# SERVICE LETTER

No. 525

Piper Aircraft Corporation

Subject: Addition of Lock Washers to Electrical Switch Installations

# Typical Switch Installation

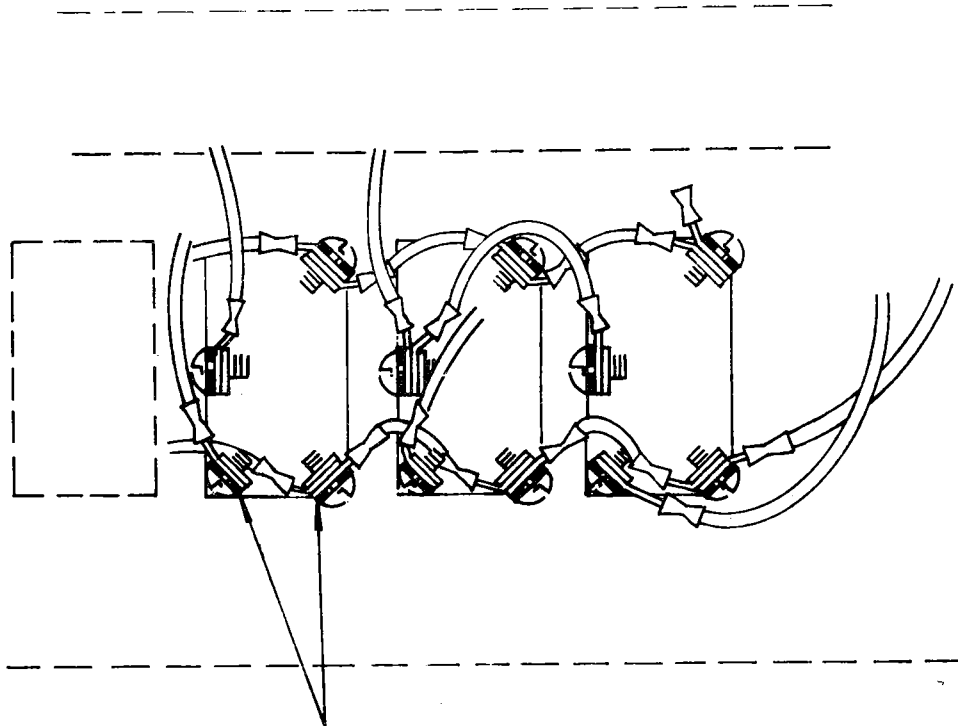
Instructions: Visually inspect the following switch installations to determine if lock washers (AN936-A6, Piper part number 407 133), have been installed under the head of each terminal screw.

Lock Washer (AN936-A6) must be installed under screw head on each switch terminal.

## Typical Circuit Breaker and Circuit Breaker Bus Bar Installation

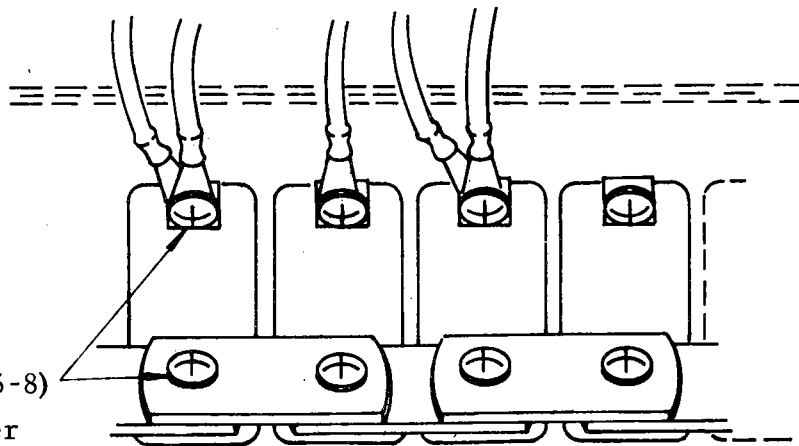
It will also be necessary to inspect the circuit breakers and circuit breaker bus bars pertaining to the above switch installations to determine that lock washers (AN935-8, Piper part number 407 103) have been installed under the head of each terminal screw.

Lock Washer - (AN935-8) must be installed under screw head at each circuit breaker terminal.
